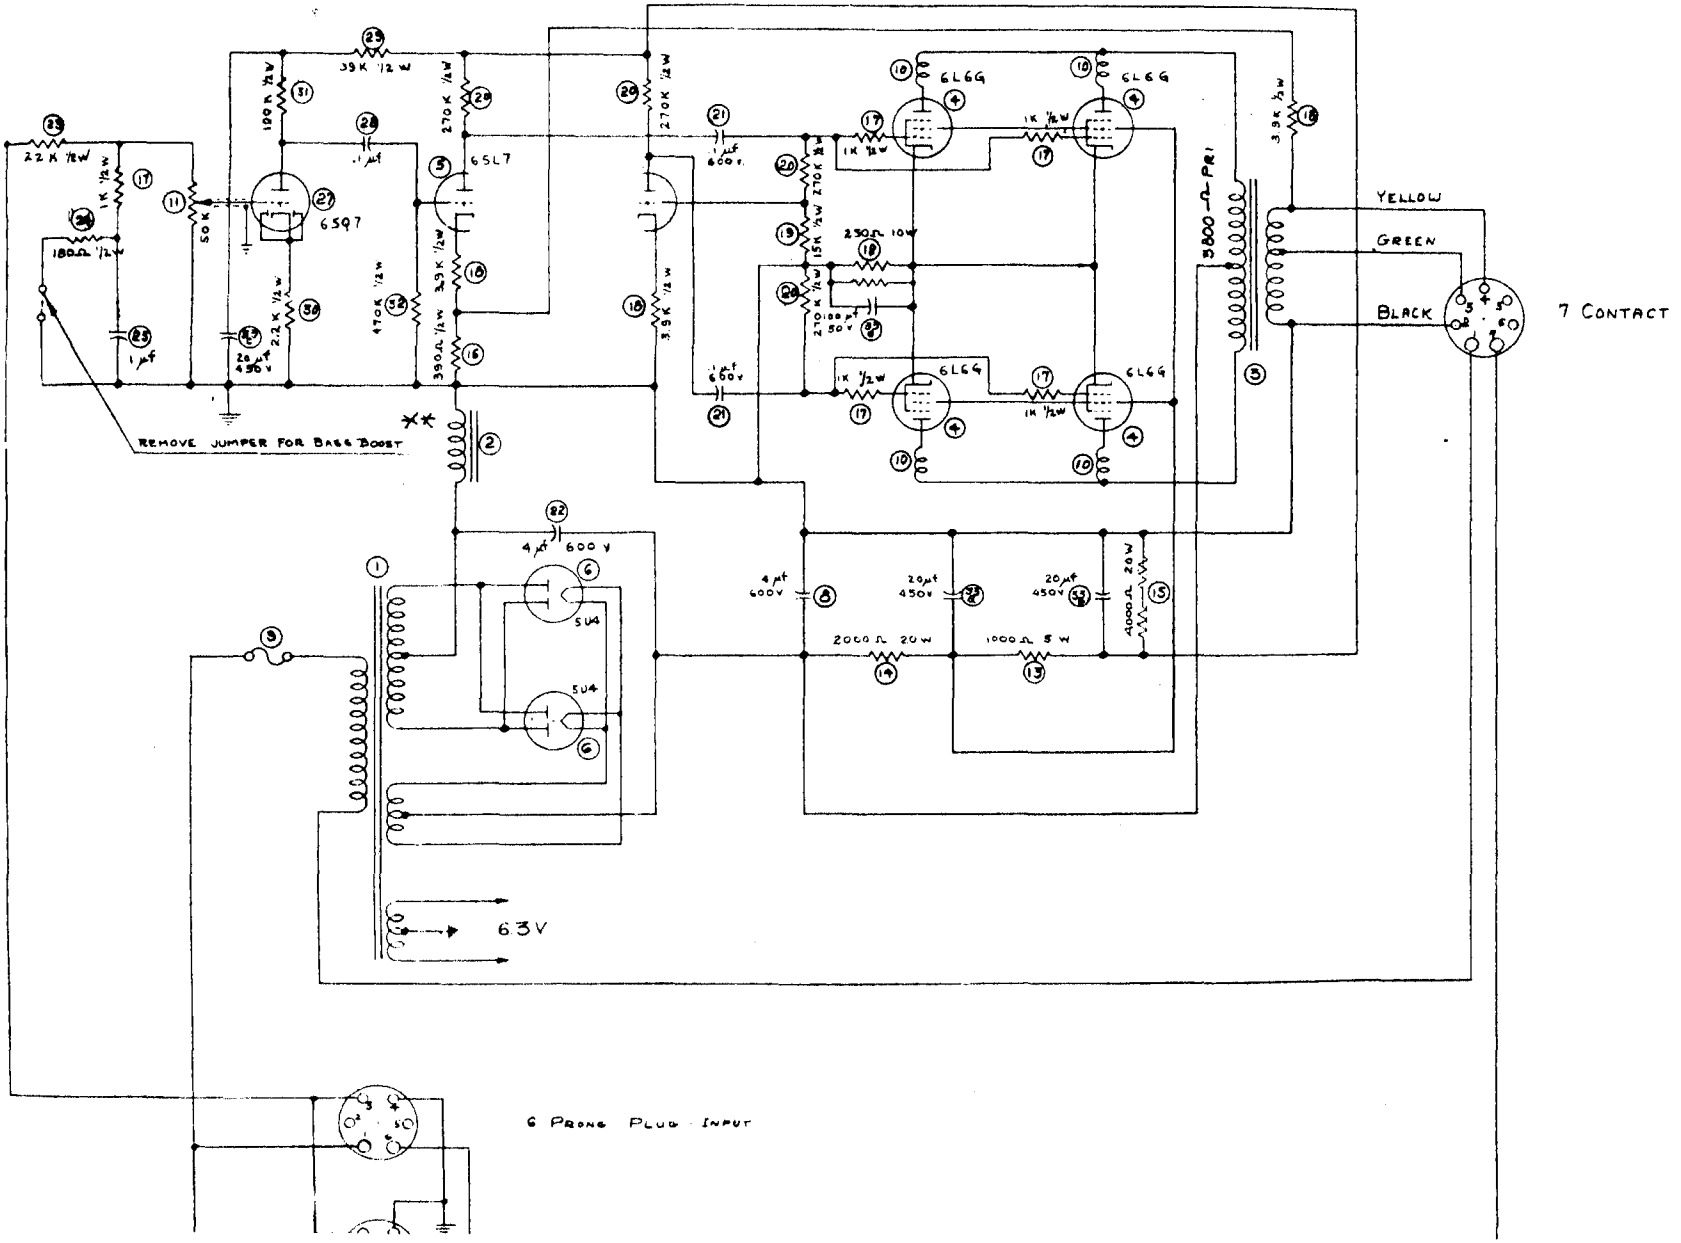
NOTE: THE REVISED PC AMPLIFIERS USED A TYPE 12AX7 PHASE INVERTER TUBE IN PLACE OF THE 6SL7. ALSO, ITEM 16 WAS DELETED; THE VALUE OF THE 3.9K FEEDBACK RESISTOR (ONE OF 3 UNDER ITEM No. 18) WAS INCREASED TO 39K AND CONNECTS FROM THE 16 Ω OUTPUT ON THE OUTPUT TRANSFORMER TO THE CATHODE OF THE INPUT HALF OF THE PHASE INVERTER.
